# Uniform Mitigation Verification Inspection Form: Issues and Recommendations

September 22, 2010

**Applied Research Associates, Inc.**

# 1. Building Code: Immediate Change

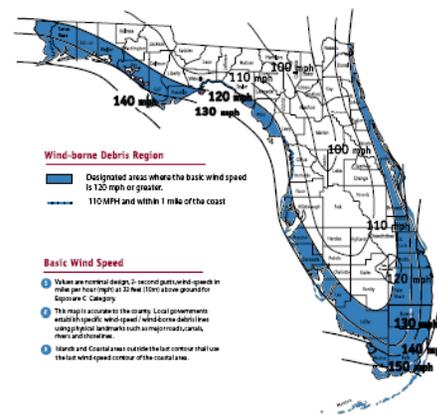
## 1. Original permit date and/or year-built information\*

- a) Building permit appl. date (MM/DD/YYYY) \_\_\_\_\_, or
  - Not available
- b) Year built (YYYY) \_\_\_\_\_, or
  - Not available
- c) Source of year built information (complete only if year built provided in (b))
  - Tax Records  Insurer  Other \_\_\_\_\_

\* Permit application date required for New Construction credits if year built is 2002 or 2003.

State of Florida  
Wind-Borne Debris Region

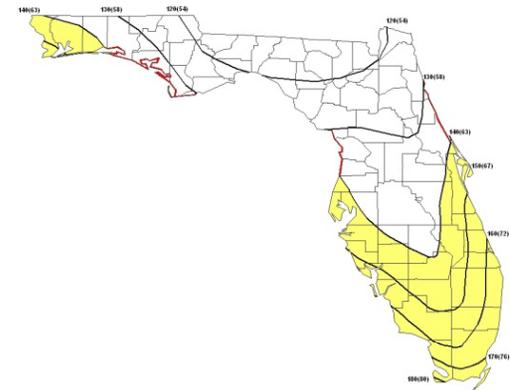
- Address “2006 FBC” changes examined in 2008 study
- Planned adoption of ASCE 7-10 by the FBC on 12/31/2011 will mean significant changes for Florida
  - Basic wind speeds
  - Windborne debris region
  - Exposure D

# 5. Roof Shape

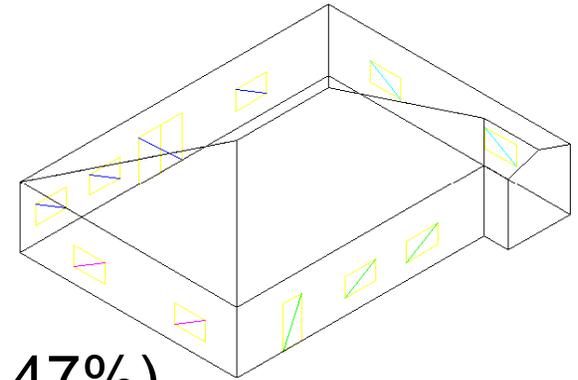
- A lot riding on this answer (big discounts)
- Clarification needed
  - Perimeter
  - Dormers
  - Dutch hips
  - Structurally connected

- Record total length of non-hip features as a % of the total perimeter
  - Define perimeter as roof edge to facilitate verification through use of aerial photography
- Remove “C. Flat Roof”
  - Not on OIR-B1-1699
  - Hip and non-hip are already mutually exclusive and collectively exhaustive
  - Create separate form for buildings with 5 or more units

# Increase in Loss: Hip vs. % Gable

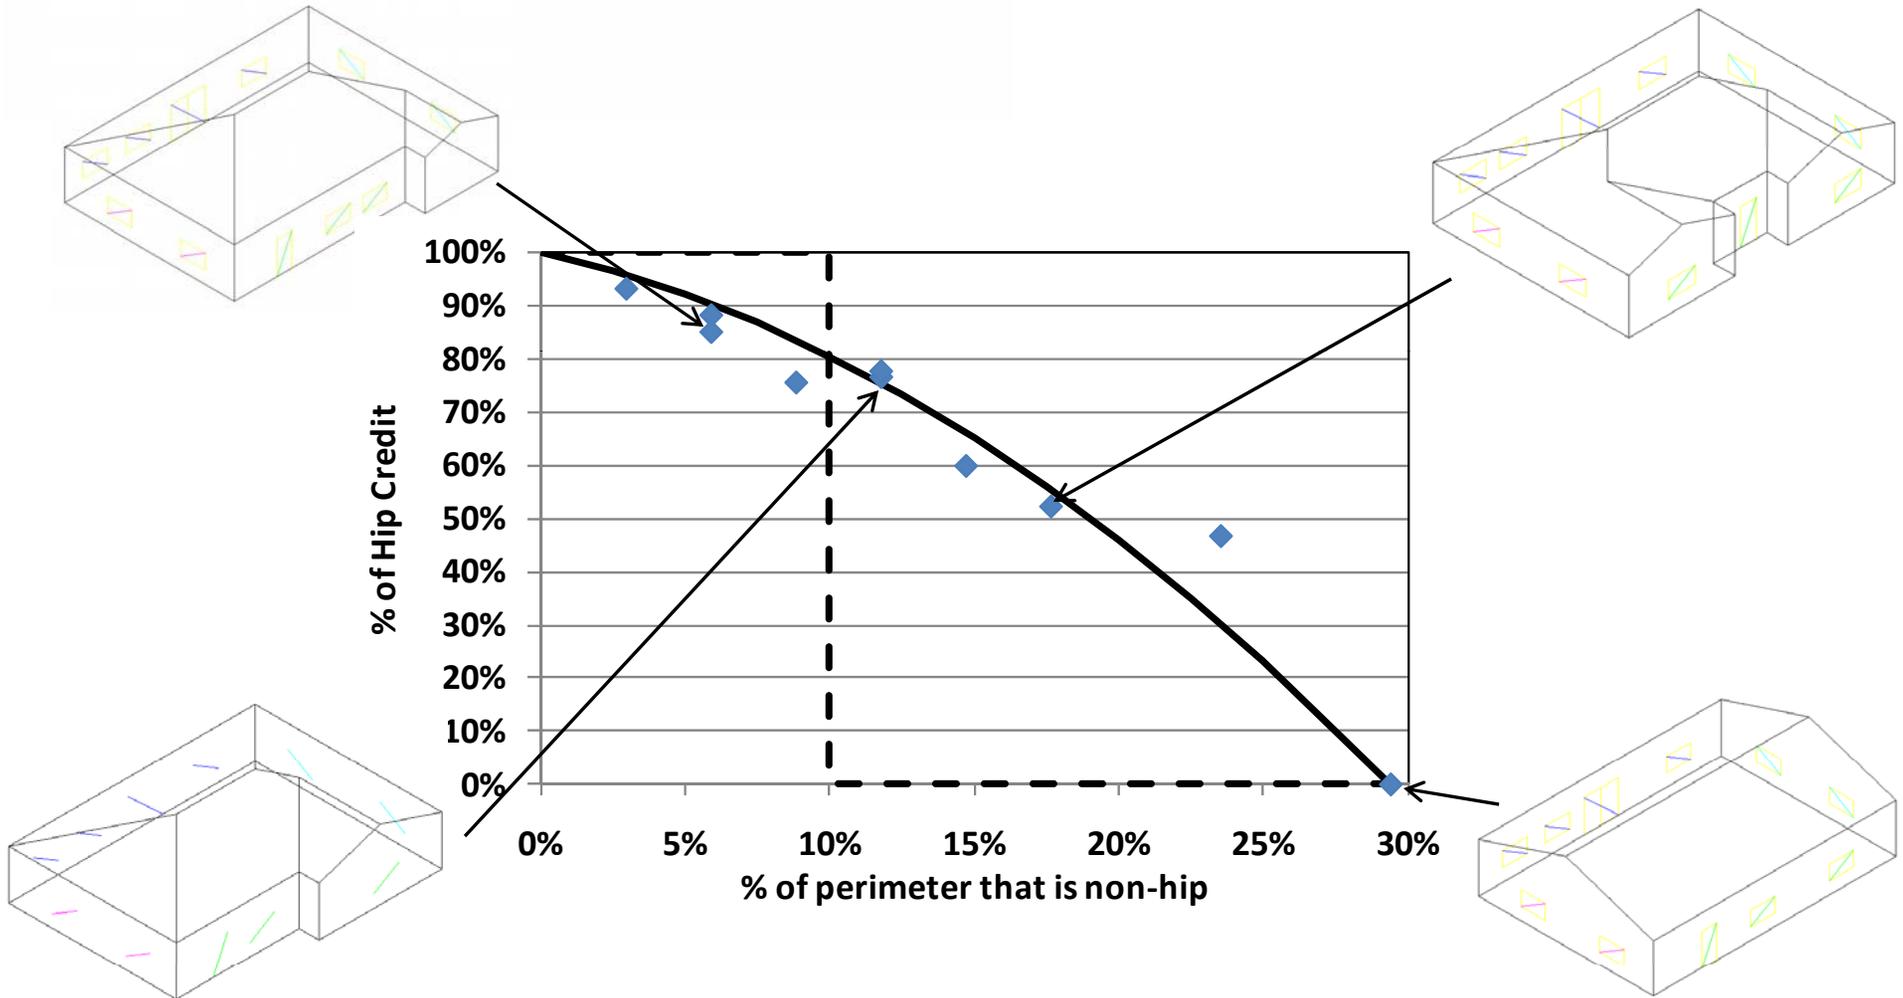
- Hip roof credit is very significant (up to 47%)
- Typical hip roof credit is 15% to 20%
- Hip and gable definitions vary with insurers
  - 2007 UMVIF
    - ✦ Hip roof if “there are no other roof shapes greater than 50% of any major wall length”
  - 2010 UMVIF
    - ✦ Hip roof if “there are no other roof shapes greater than 10% of the total building perimeter”

# 5. Roof Shape: 2011 Form

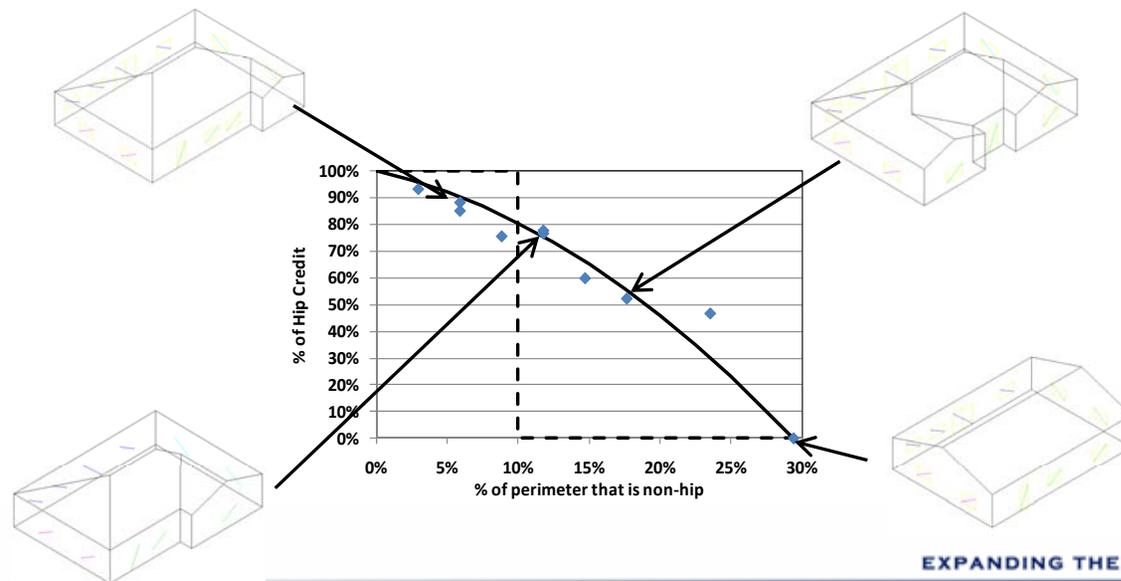
- Perform additional sensitivity studies on a wide variety of realistic roof shape configurations
- Record percent non-hip
- Interpolate credit between pure hip and pure gable
